Subject: Crystal River Unit 3
Docket No. 50-302
Operating License No. DPR-72
Environmental Protection Agency 316 Study

NOTES OF CONFERENCE
THIRD QUARTERLY PROGRESS MEETING
FLORIDA POWER CORPORATION

Enclosed is a copy of the Notes of Conference from the Third Quarterly Progress Meeting for the Crystal River 316 Study held in St. Petersburg on May 3, 1984.

Temperatures (°C) HWS
8/13/83 1740 - 1840

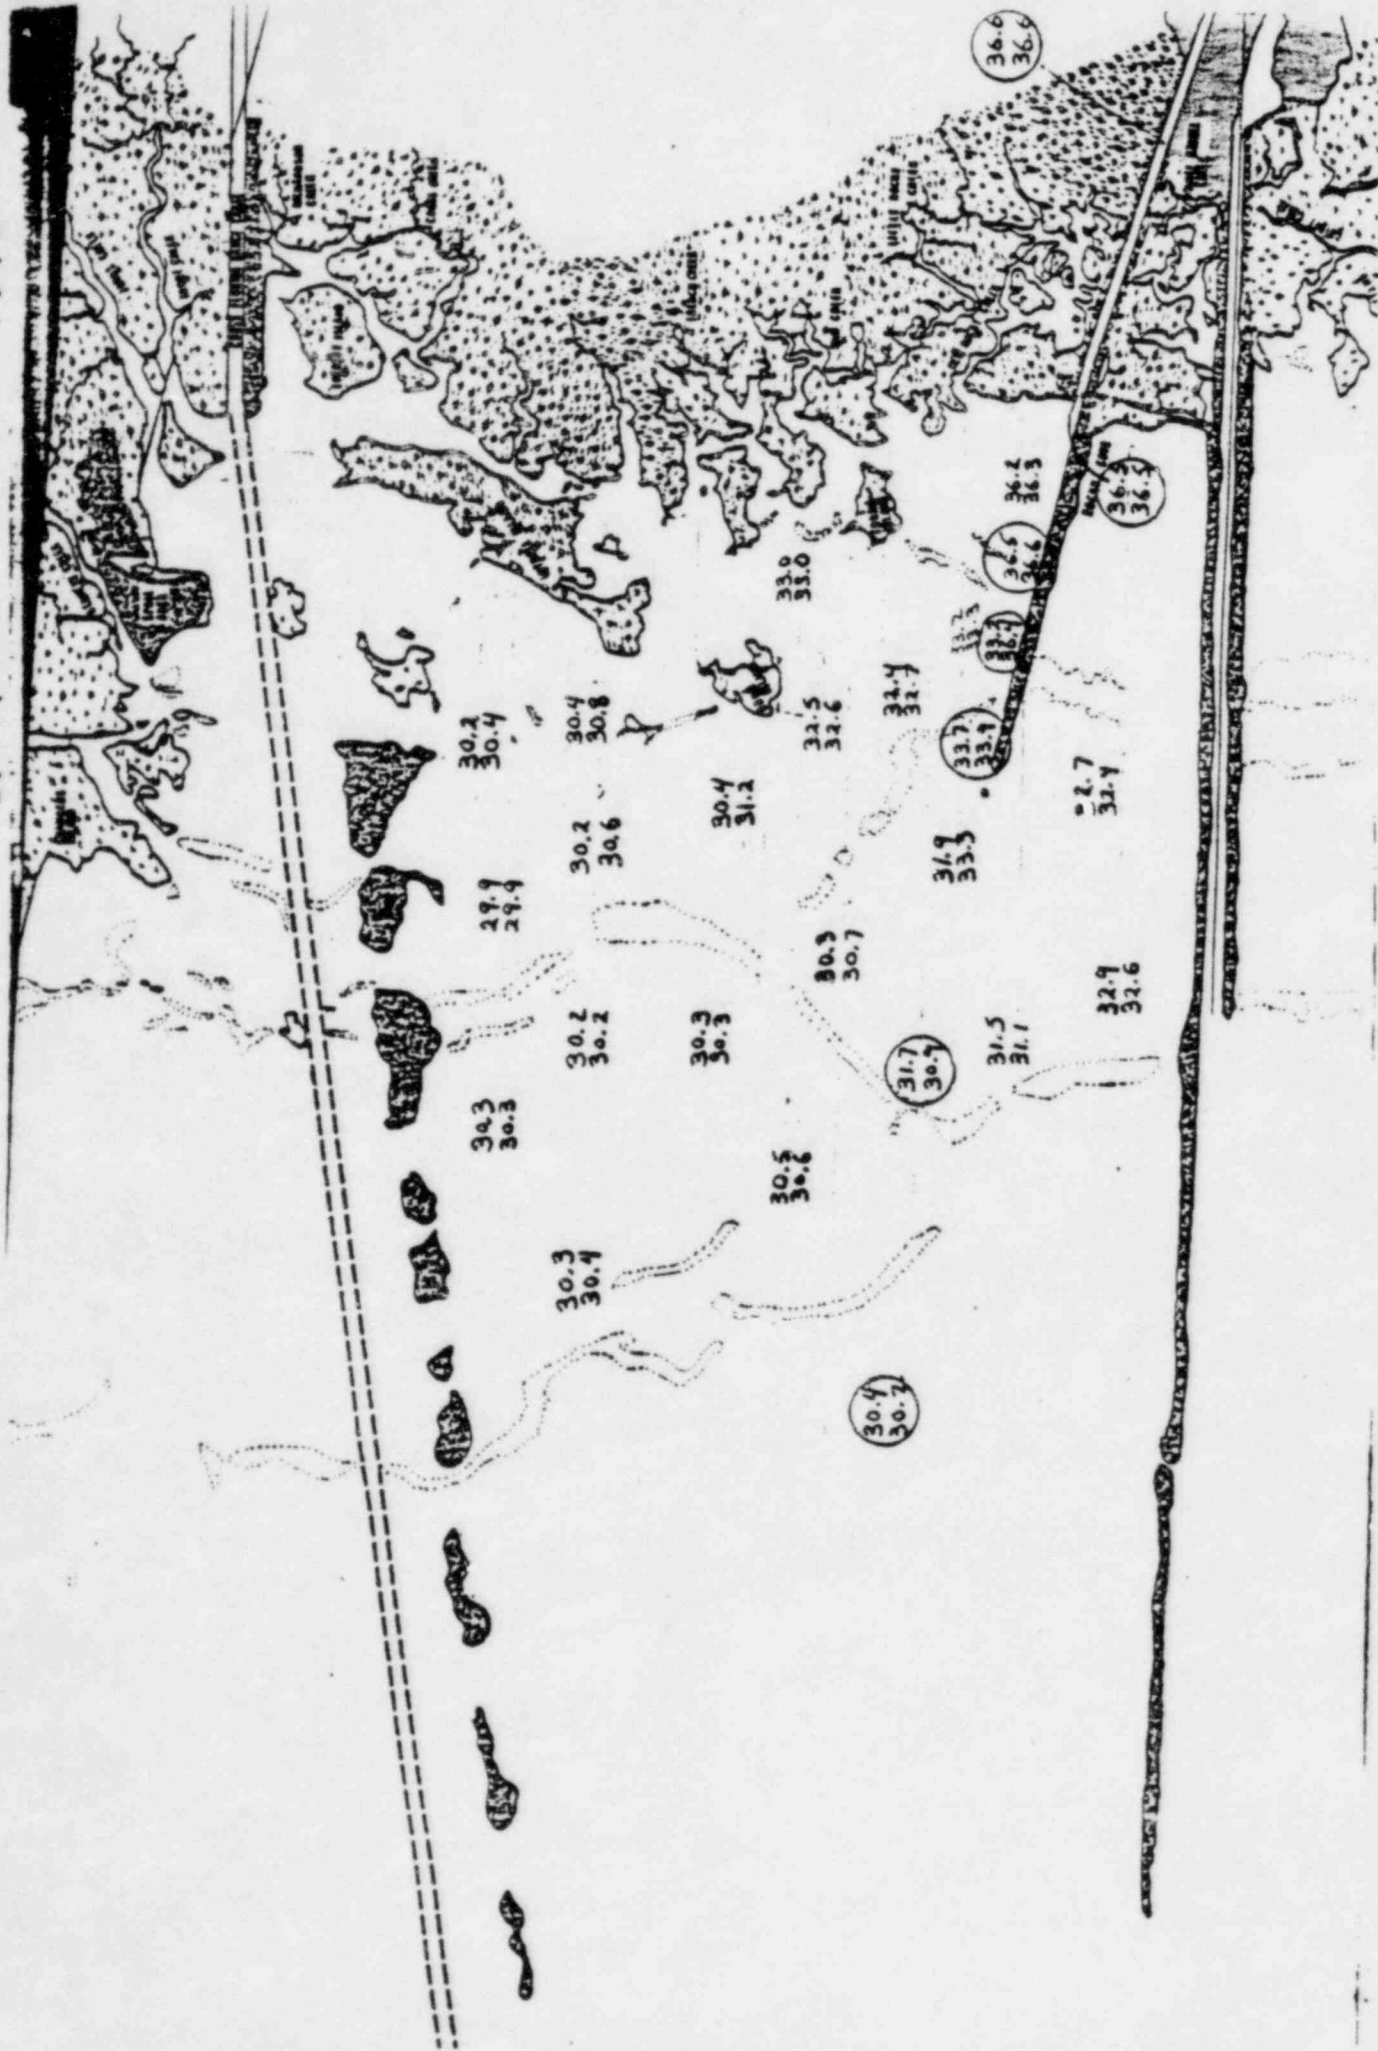
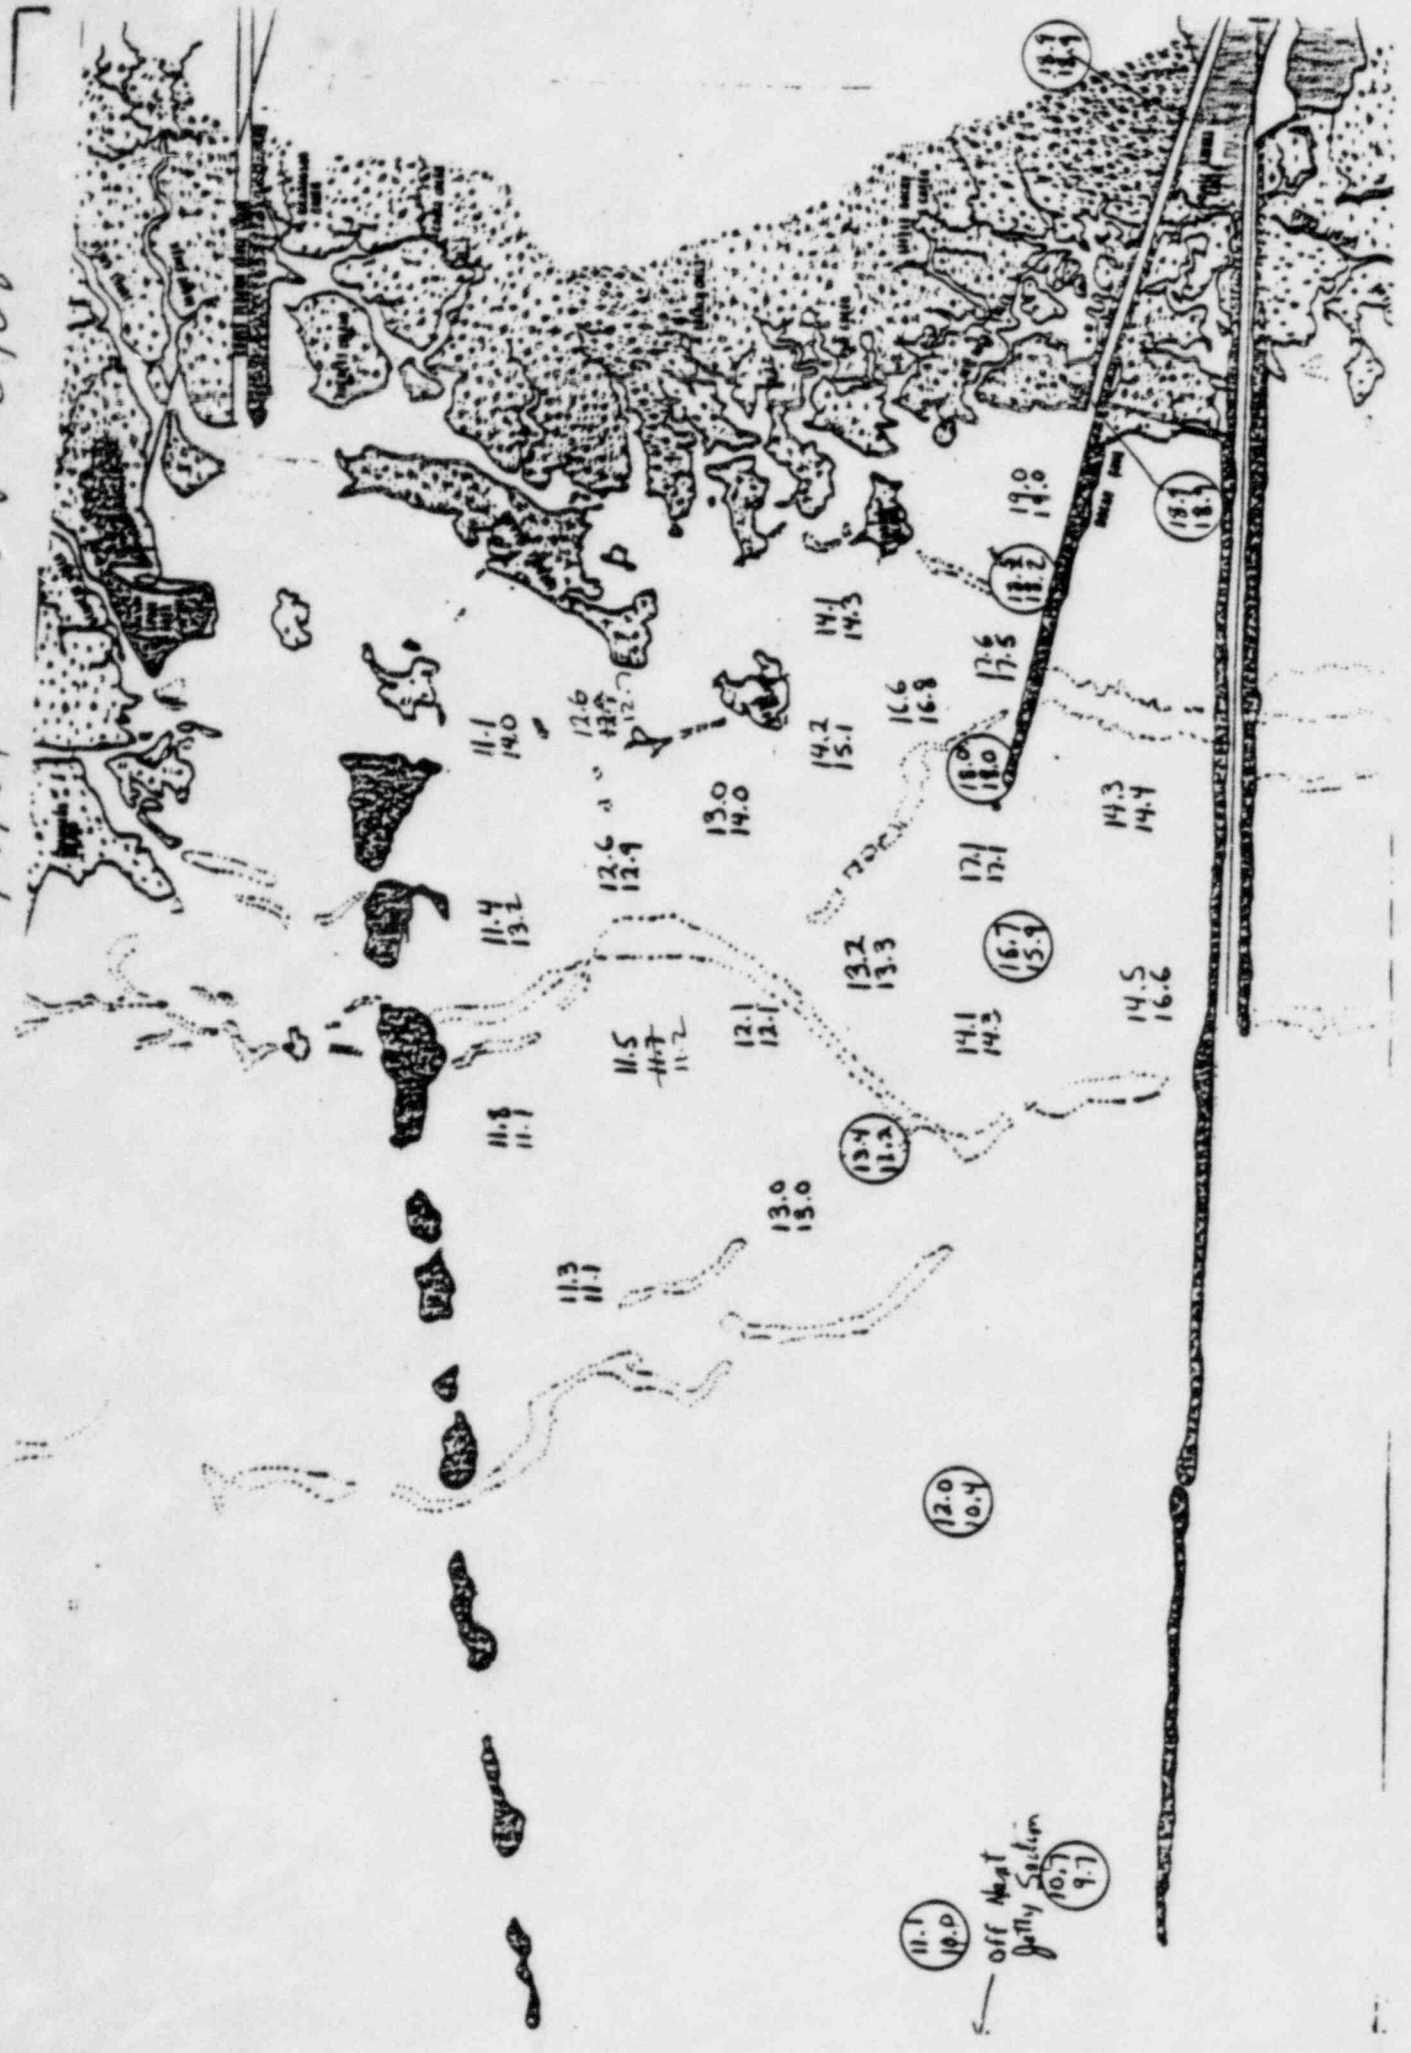
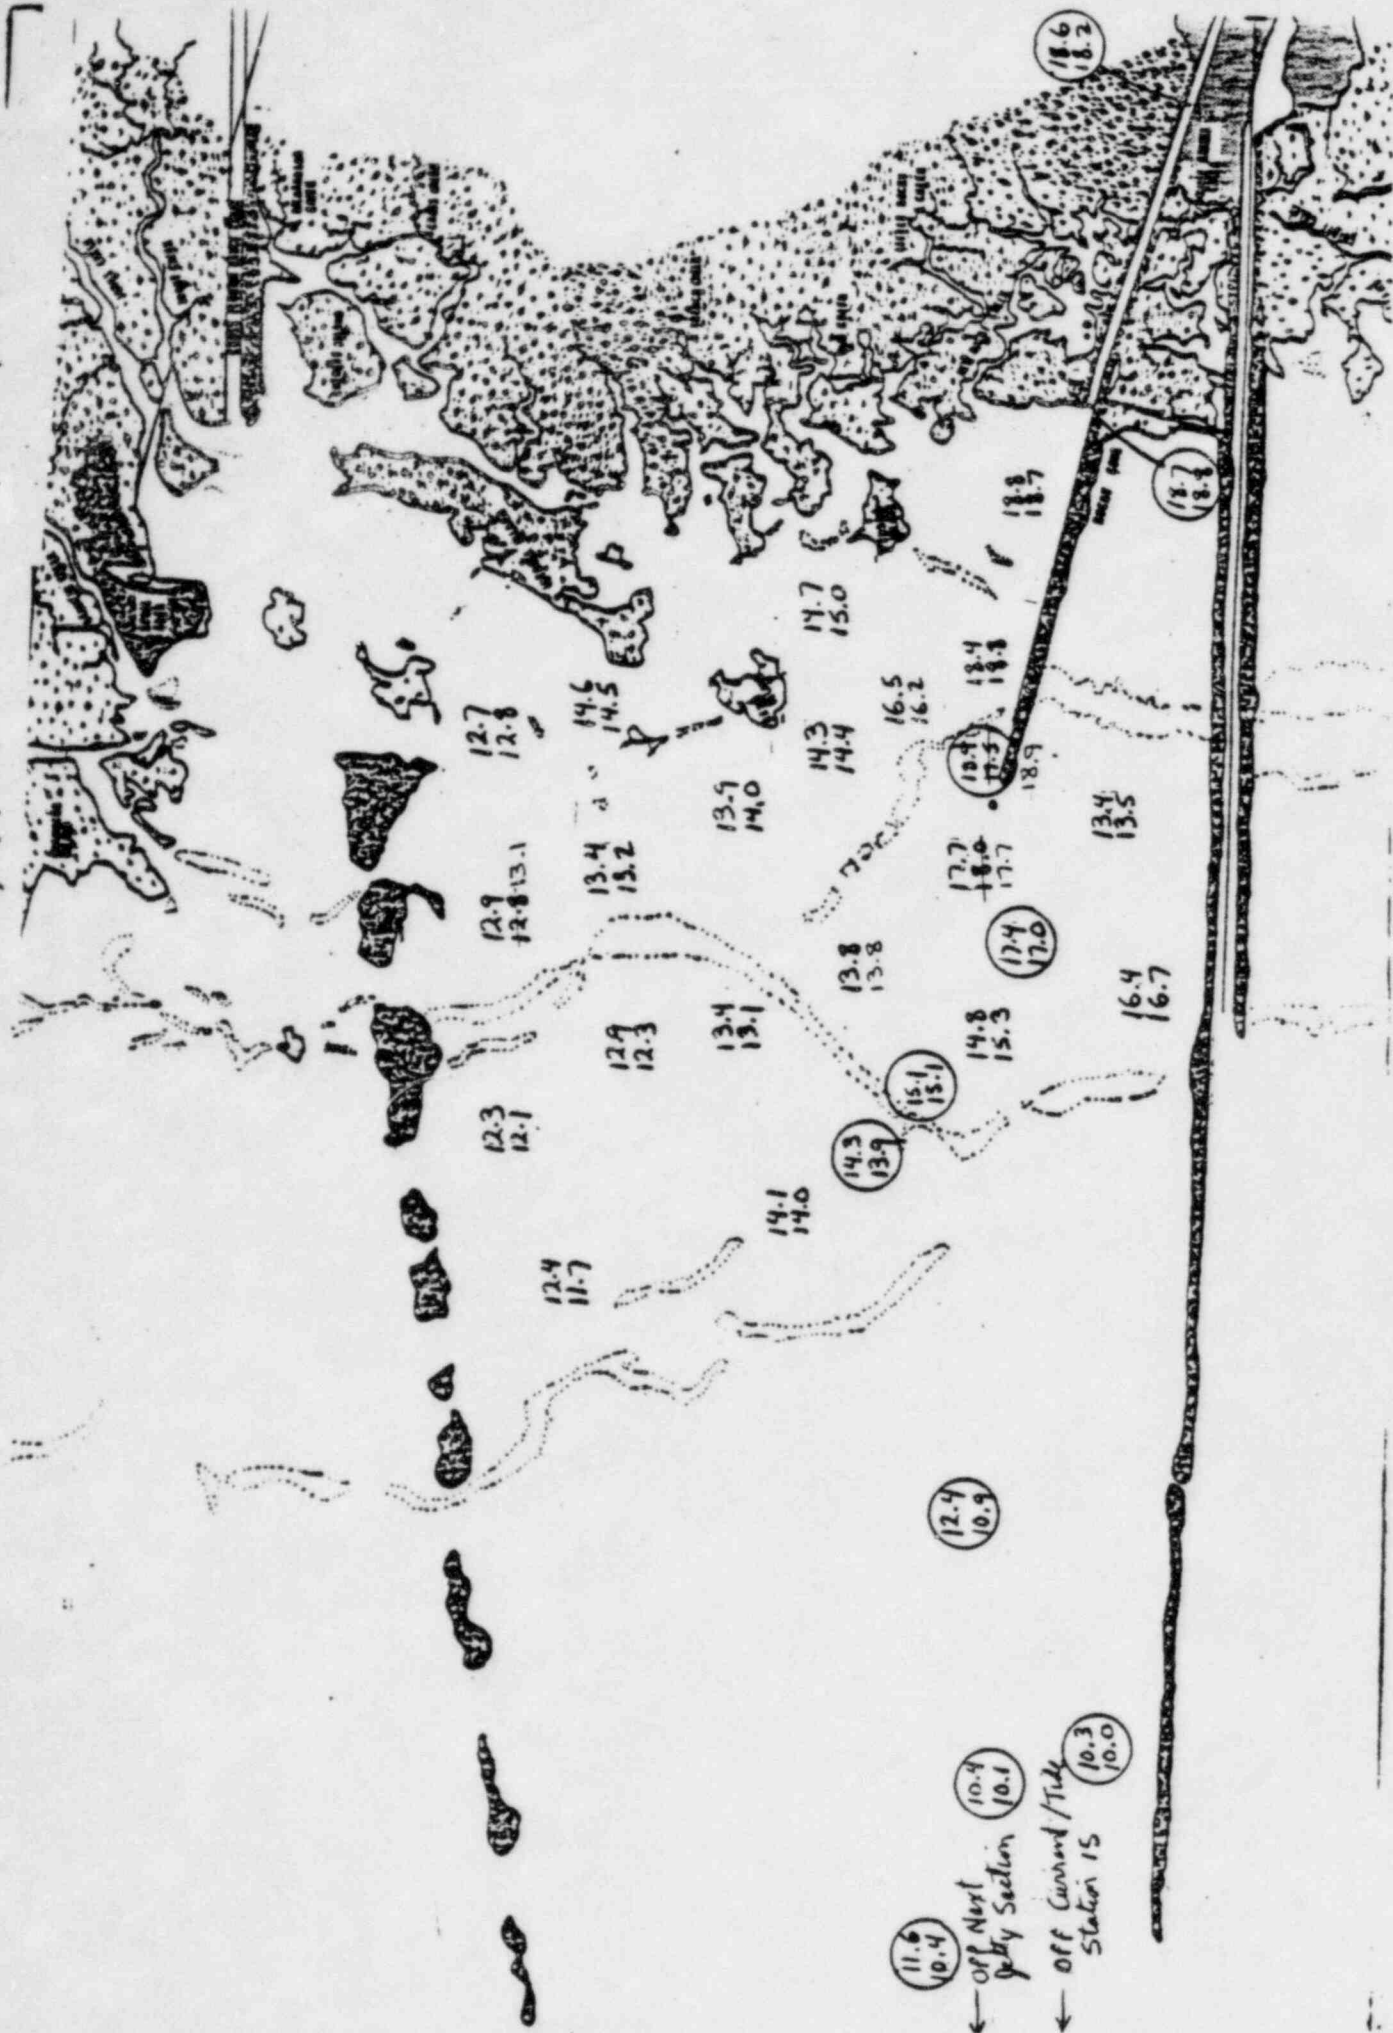
+ no. checks in the field log

* No. is correct based on field log, however a +5° reading error could exist in one measurement. the bottom value then becomes 31.7

- Revised tables of June temperature and conductivity. These tables have been changed to reflect a 90 minute, rather than a 2 hour, tide window and to correct incorrectly specified times for maximum tide.
- July, 1984, temperatures by week.
- Juncus marsh data for October, 1983.
- Entrainment densities for July 21, August 31 (2), September 14, and September 27.
- Fourteen figures showing temperatures monitored in August and January. Also, please note that a few uncircled temperatures have been found to represent single readings in contrast to the absolute statement on Page 4-1 of the Quarterly Report, however, they remain uncircled to distinguish the readings from ones taken by the "chase" boat.
